### World Forum for Harmonization of Vehicle Regulations

## **Proposal for Supplement 1 to the 09 series of amendments to UN Regulation No. 48 (Installation of Lighting and Light- Signalling Devices)**

### **Submitted by the Working Party on Lighting and Light-Signalling\***

*Annex 16, amend to read:*

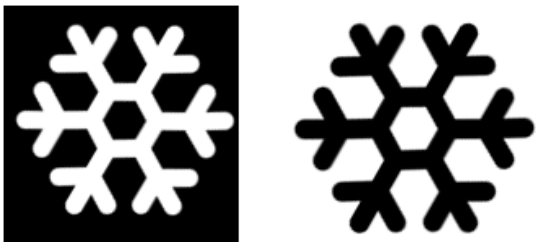
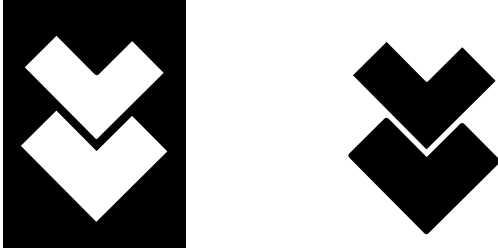
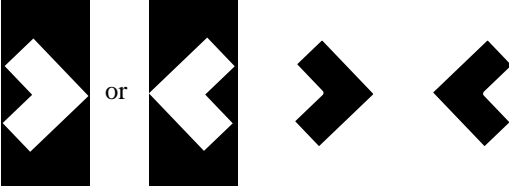
### **Symbols and patterns for the use as Driver Assistance Projections and Explanations of the Warnings/Highlights**

<i>Symbols and Pattern</i>	<i>Use case</i>	<i>Conditions and remarks</i>
	Slippery road warning	
	Risk of collision warning	<p>Triggered when the relative speed is larger than 30 km/h and Risk of Collision Time is less than 1.4 s.</p> <p>Flashing at 4.0 hz +/- 1.0 hz allowed.</p>

Wrong way warning	Activated when the vehicle is entering a one-way road or a highway in opposite direction.  Flashing at 4.0 hz +/- 1.0 hz allowed.
	Lane keeping assist warning	Activated if the vehicle unintentionally exits its lane.
 <p>This figure is showing an example of the basic quadrilateral shape of the Driver Assistance Projection for predicted trajectory, as seen from the driver's perspective of a car in straight forward motion. The dashed lines are not part of the projection. They are a representation of the lines delineating the lane on which the vehicle is travelling, and only added to clarify the image and lateral boundaries of the predicted trajectory projection.</p>	Predicted trajectory	This shape may change when adapted in conformity with the requirements in paragraph 5.35.12.
